**Attachment to item number 5.1 -**

## RESPONSE TO REQUEST FOR FURTHER INFORMATION - 5 INVERNESS STREET

## SITE CLASSIFICATION & DISPERSIVE SOIL ASSESSMENT REPORT

Proposed Residential Development  
5 Inverness Street, Midway Point

Figure 1: aerial imagery of 1 and 3 Oakmont Road, googleearth, 2025

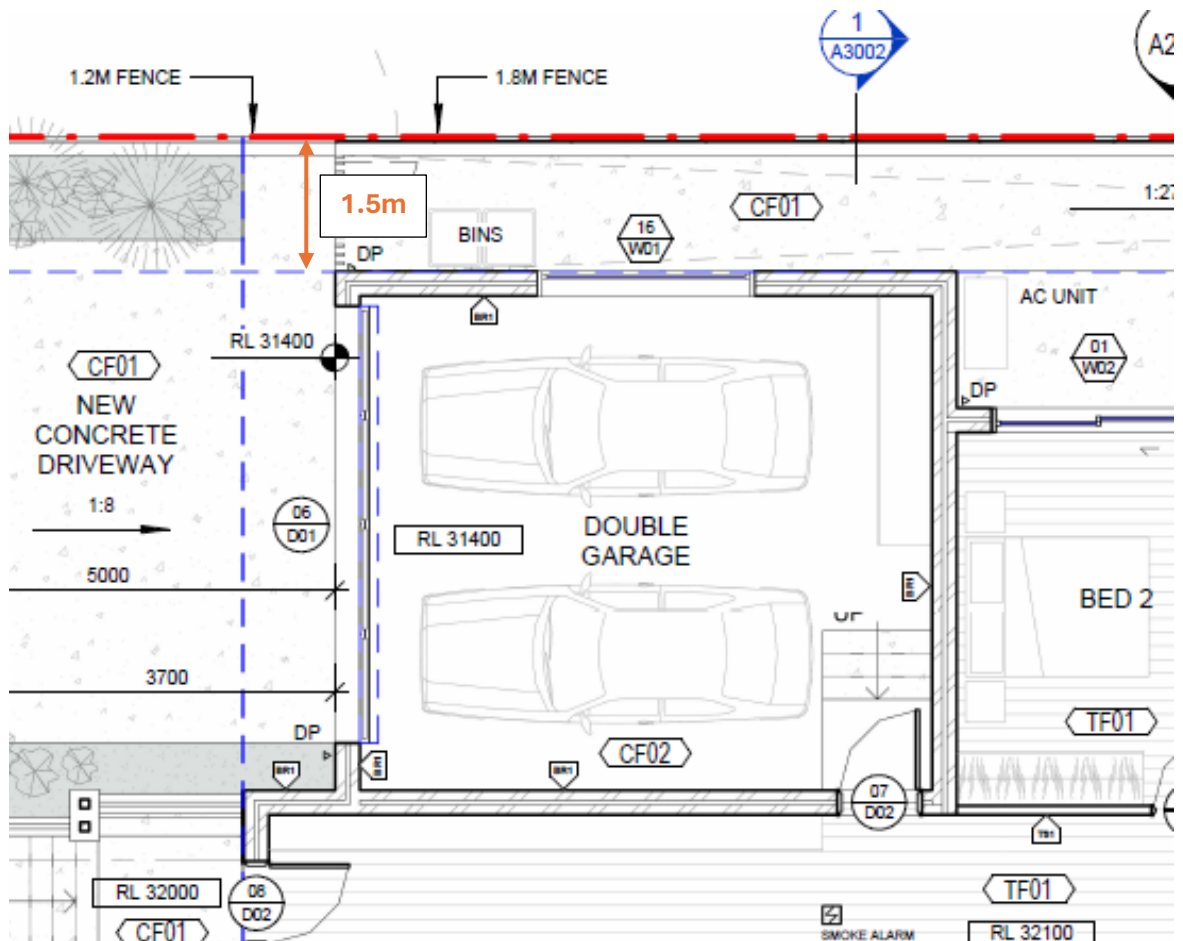
b) This provision pertains to the separation of existing, established properties within the area. The closest developed dwellings are located northwest of the proposal at 1-3 Oakmont Road, with the following setbacks observed between the two dwellings:

The separation between the established properties at 1 Oakmont and 3 Oakmont is approximately 2.3m.

The proposed dwelling walls are setback 1.5m from side boundaries at its closes point (excluding eaves to 0.6m wide).

If future adjoining properties adhere to the acceptable solution of a 1.5m setback, the separation between the proposal and those dwellings will be 3m, which exceeds the separation seen between the existing properties in the area. Therefore, the proposal is considered to comply with the provision.

DRAWING NUMBER A8001 DRAWING TITLE Shadow Diagrams

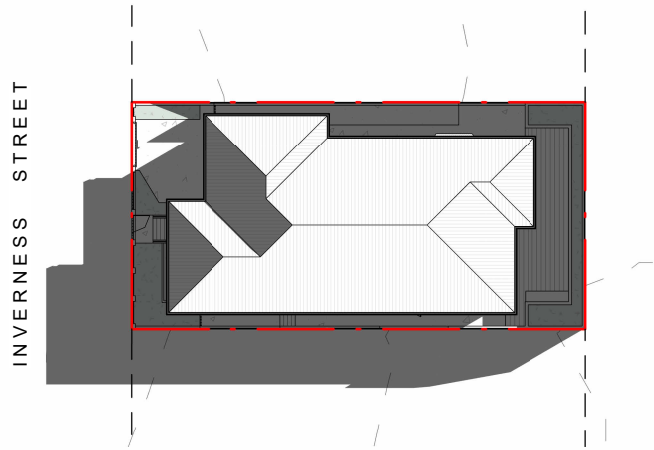
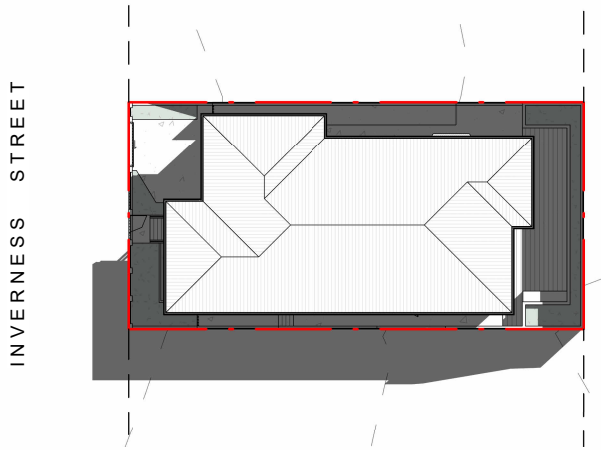
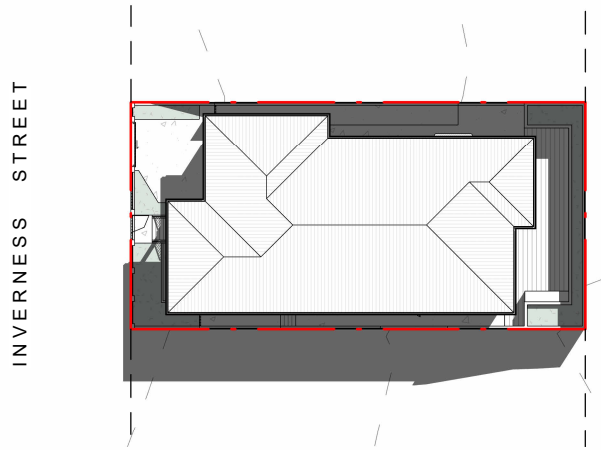
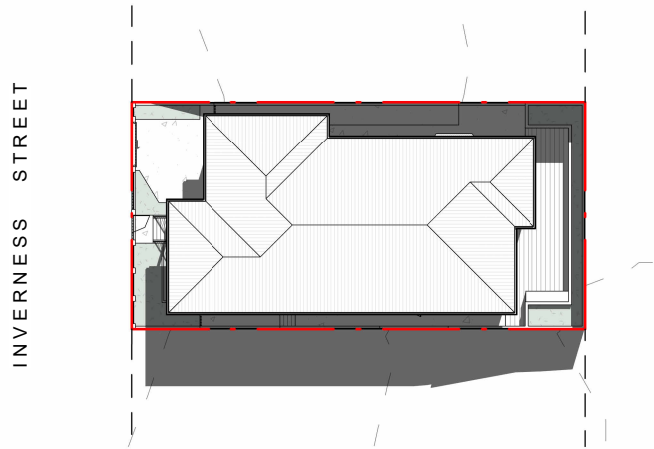
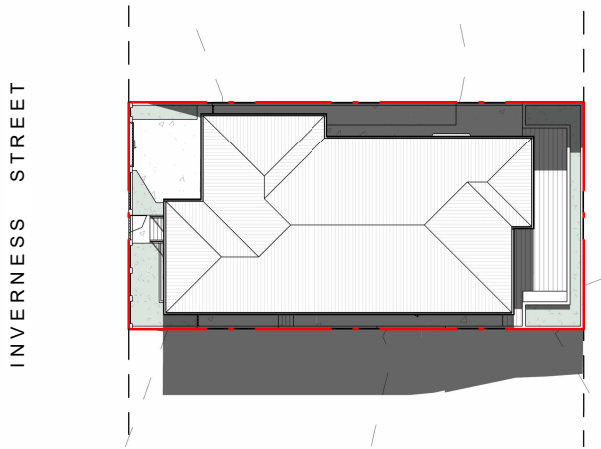
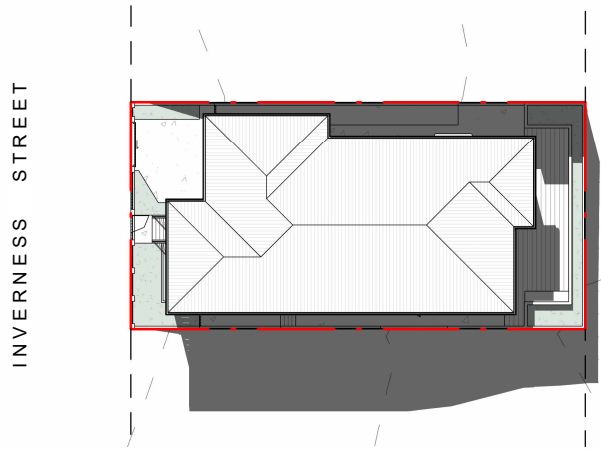
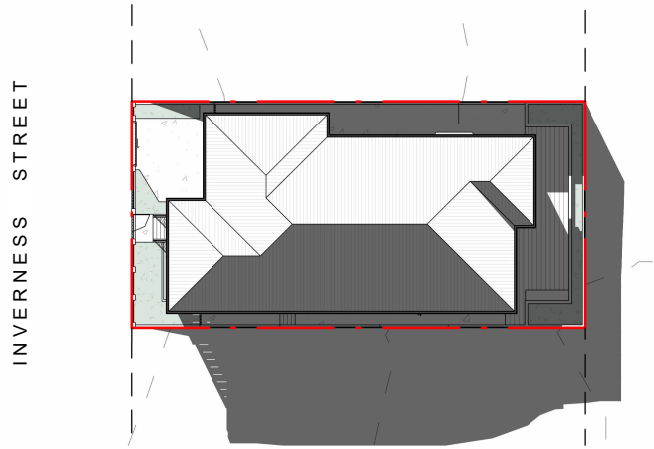
iii) Given that 7 Inverness Street is positioned directly to the south of the proposed development, some overshadowing is to be expected by any proposed development onsite. As illustrated in the attached shadow diagrams, at least 50% of the vacant lot will continue to receive direct sunlight between the hours of 9am and 3pm. This ensures that, whilst some overshadowing will occur, it will not result in an unreasonable loss of amenity to 7 Inverness Street.
